TSG-RAN Working Group 1 meeting #15
Berlin, Germany
August 22nd - 25th , 2000

R1-00-1145

Agenda item: Release 99 issues
Source: Nokia, Vodafone Group
Title: Clarification on RACH and CPCH subchannel definition
Document for: Decision

Subject: **Clarification on RACH and CPCH subchannel definition**

Figure 2: PRACH access slot and downlink AICH relation ($\tau_{p-a} = 7680$ chips)

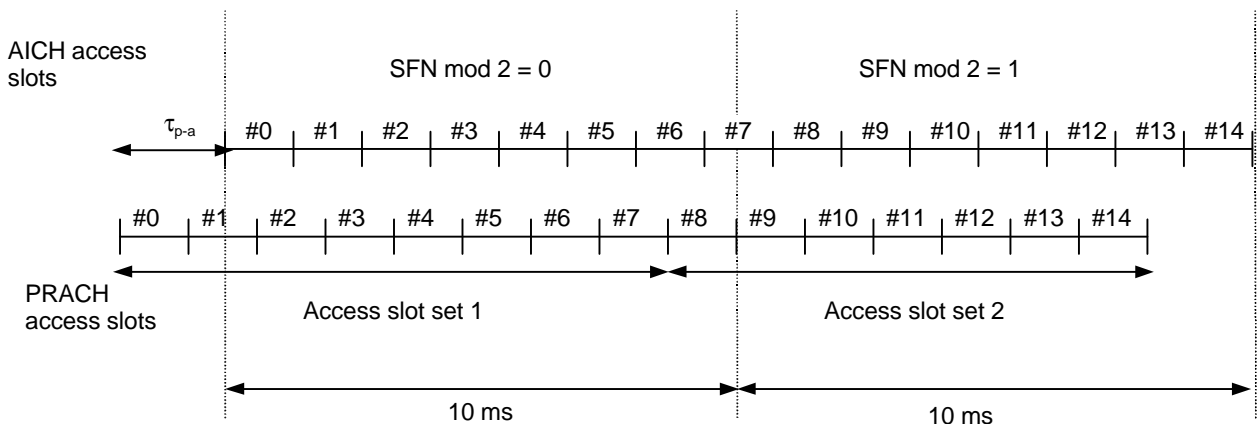
The PRACH contains two sets of access slots as shown in Figure 2. Access slot set 1 contains PRACH slots 0 – 7 and starts τ_{p-a} chips before the downlink P-CCPCH frame for which SFN mod 2 = 0. Access slot set 2 contains PRACH slots 8 - 14 and starts ($\tau_{p-a} - 2560$) chips before the downlink P-CCPCH frame for which SFN mod 2 = 1.
